ADDENDUM NO. 01
January 13, 2022

To Drawings and Specifications dated December 17, 2021

CLINE ELEMENTARY SCHOOL CAMPUS REPLACEMENT
FOR FRIENDSWOOD I.S.D.

Prepared by: PBK
11 Greenway Plaza, 22nd Floor
Houston, TX 77046-1104
PBK Project No: 20380

2 TYPICAL DETAIL FOR TRENCH BACKFILL AT EDGE OF BUILDING
NO SCALE

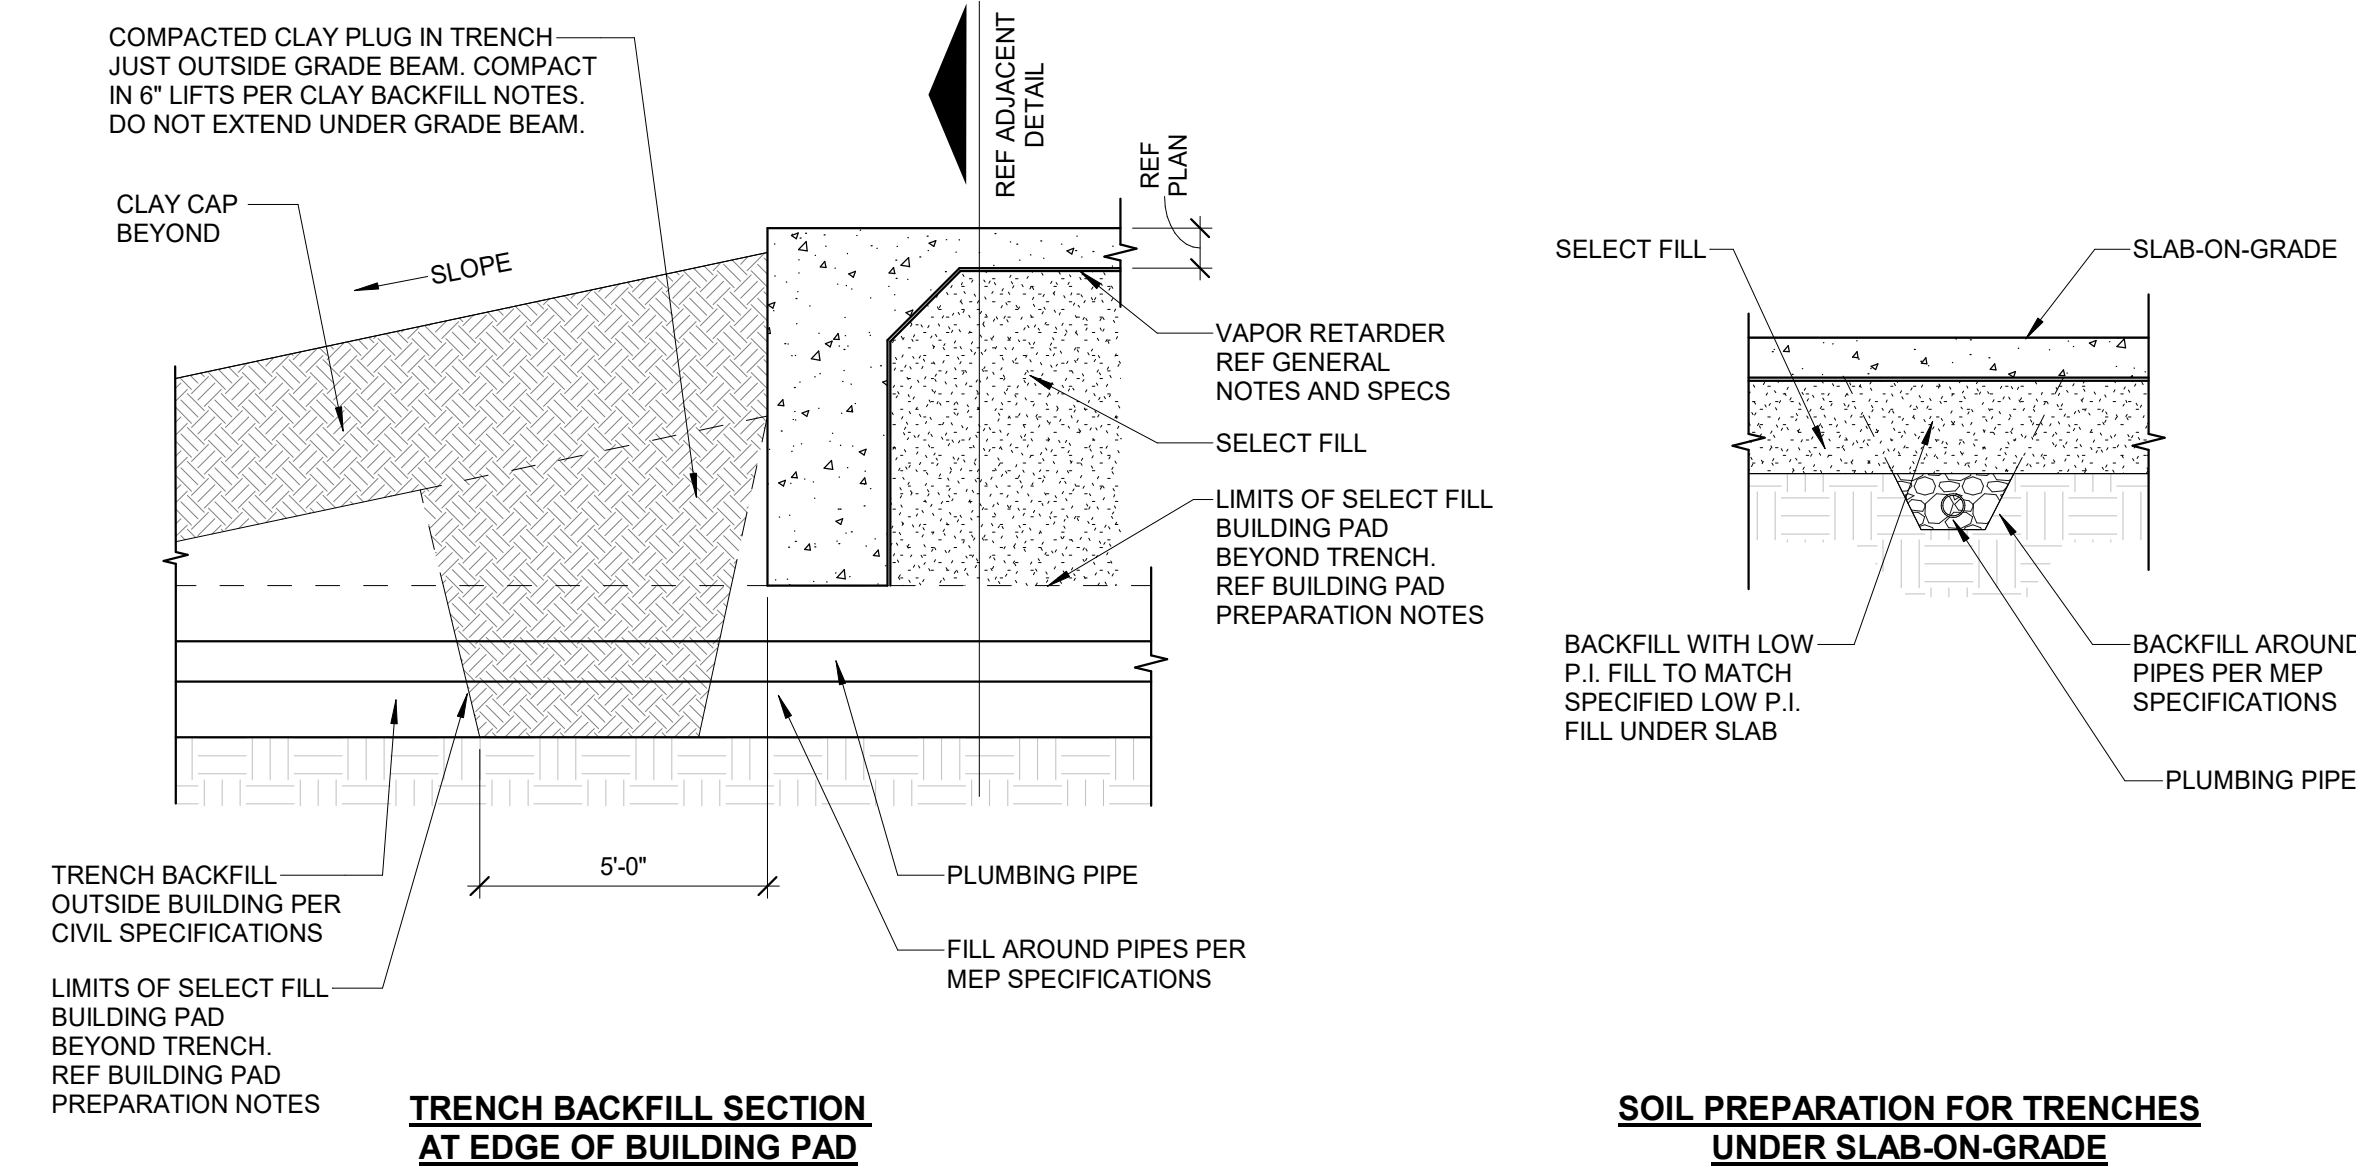
- a. Detail 1 revised. See revised sheet.

1 STRUCTURAL SITE PLAN
1" = 50'-0"

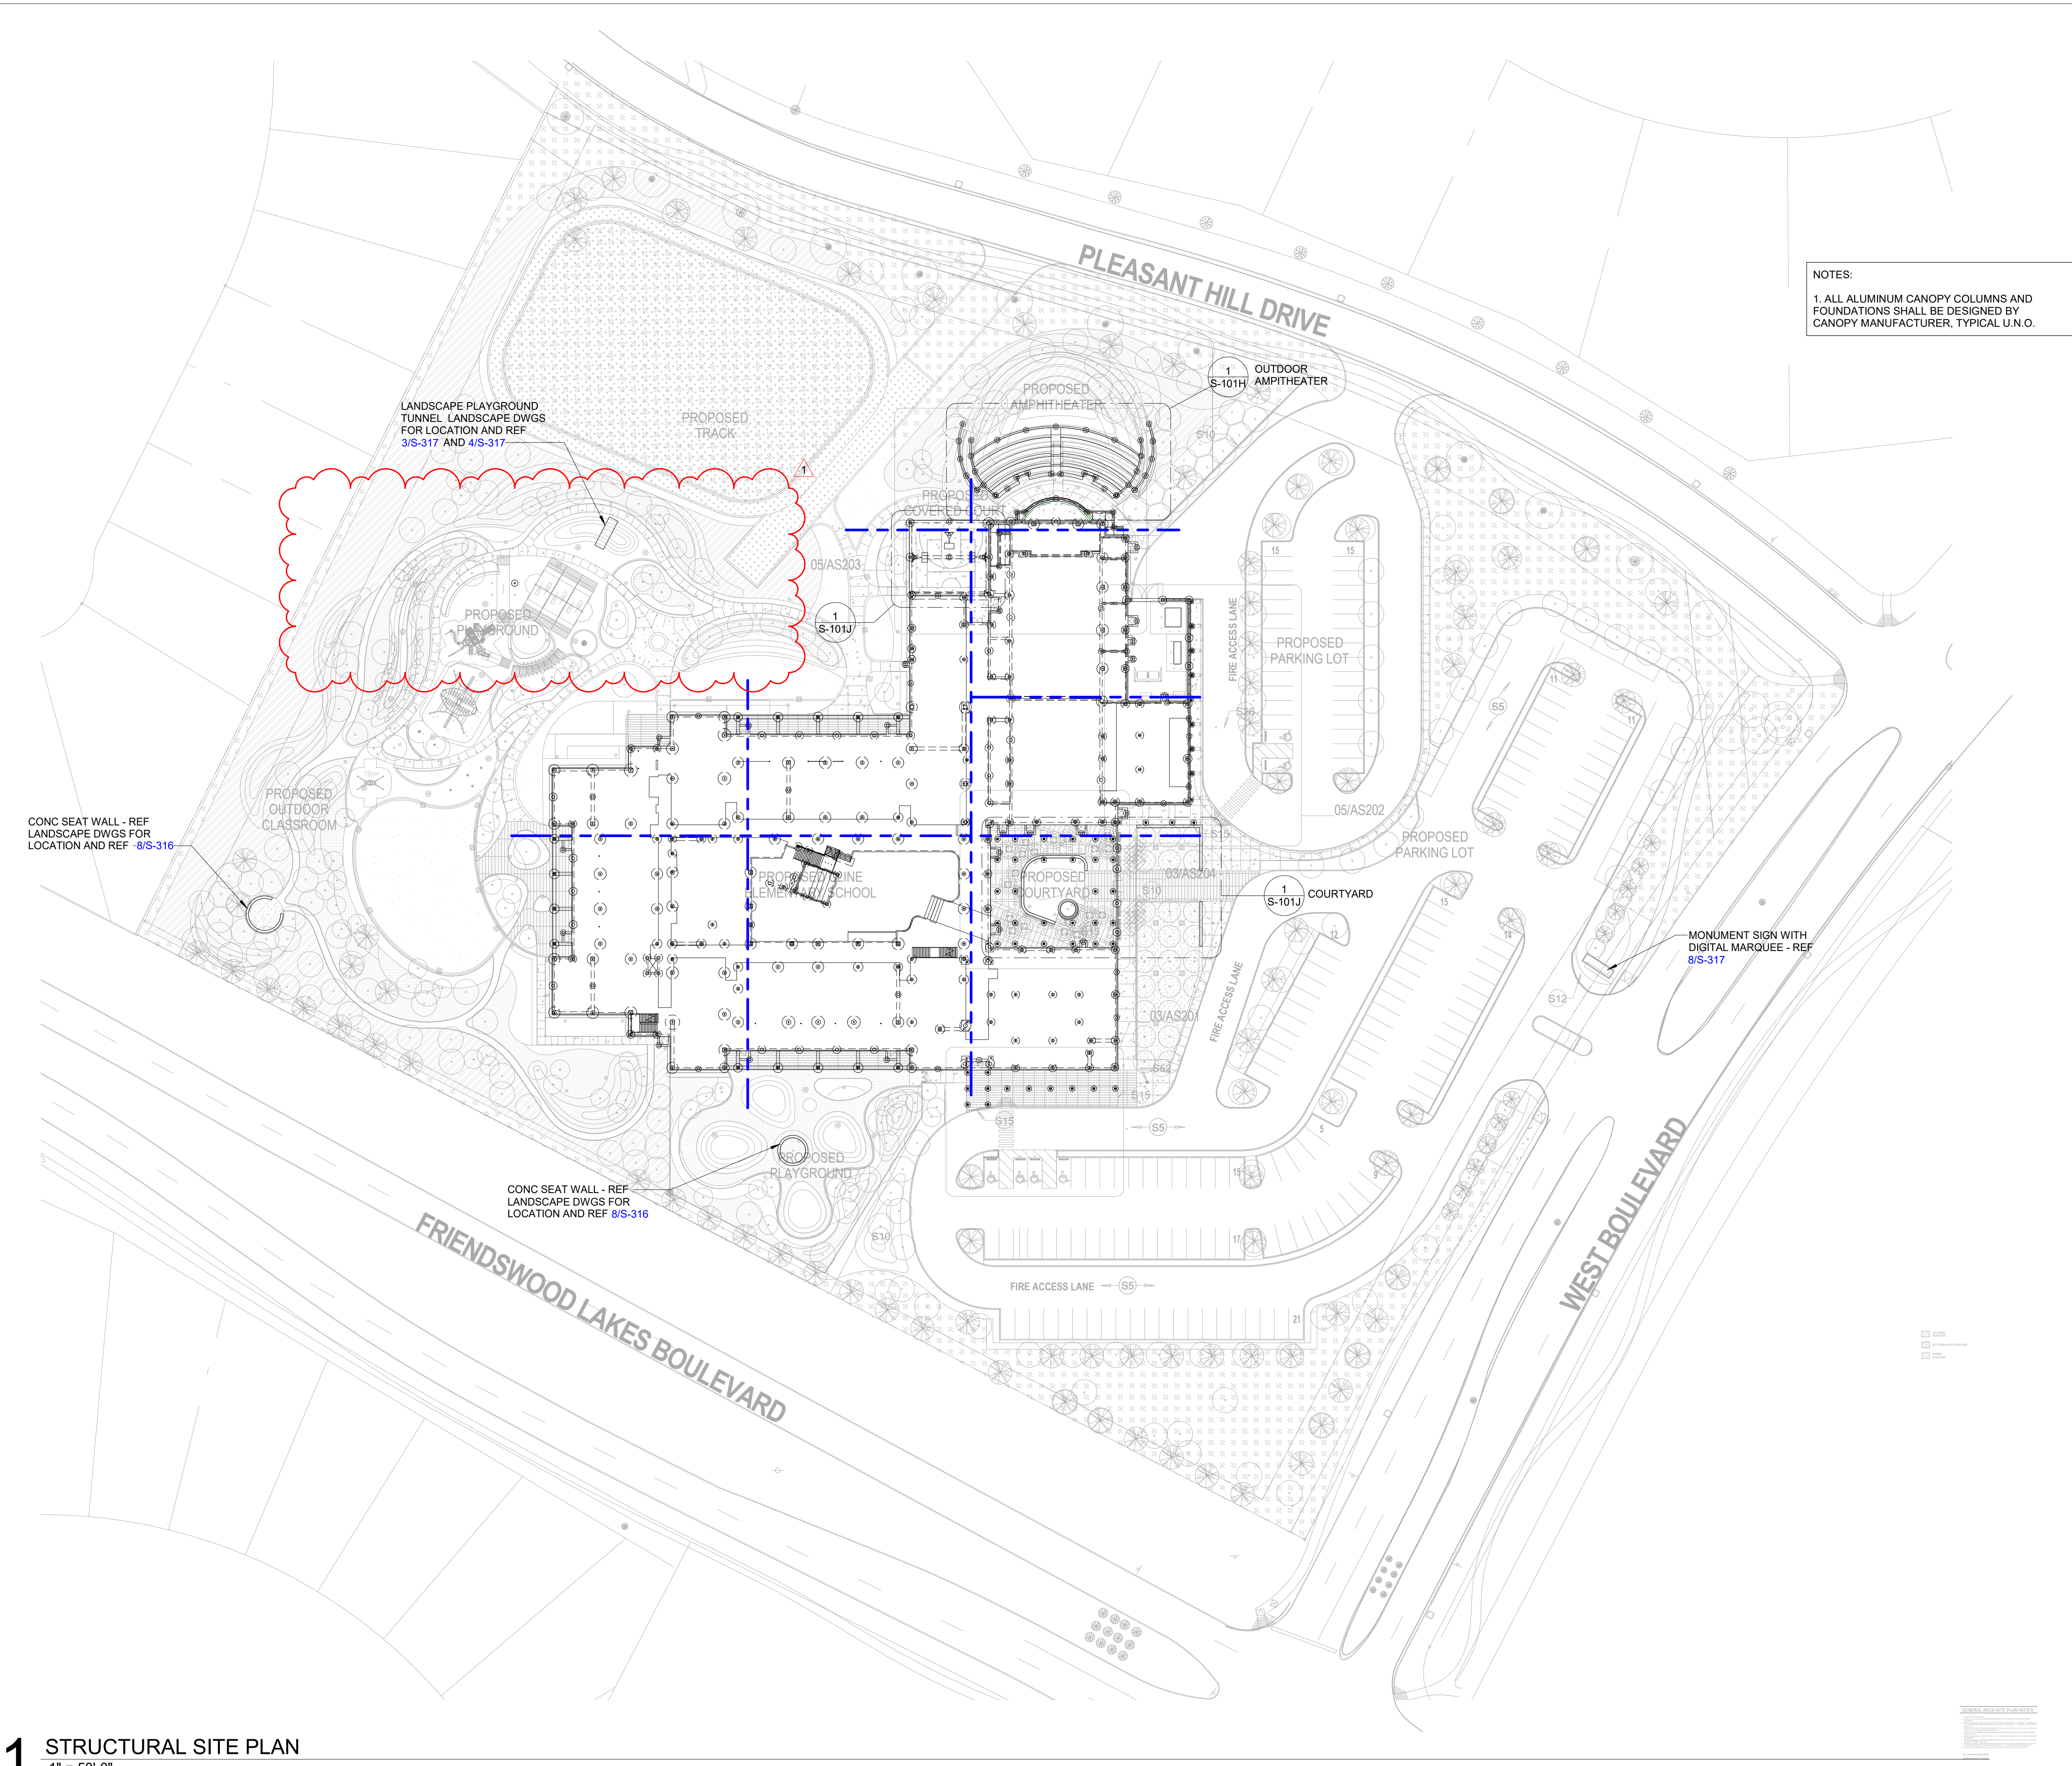
- a. (4) Concrete seat walls and (1) Landscaping retaining wall removed from site. See revised sheet.
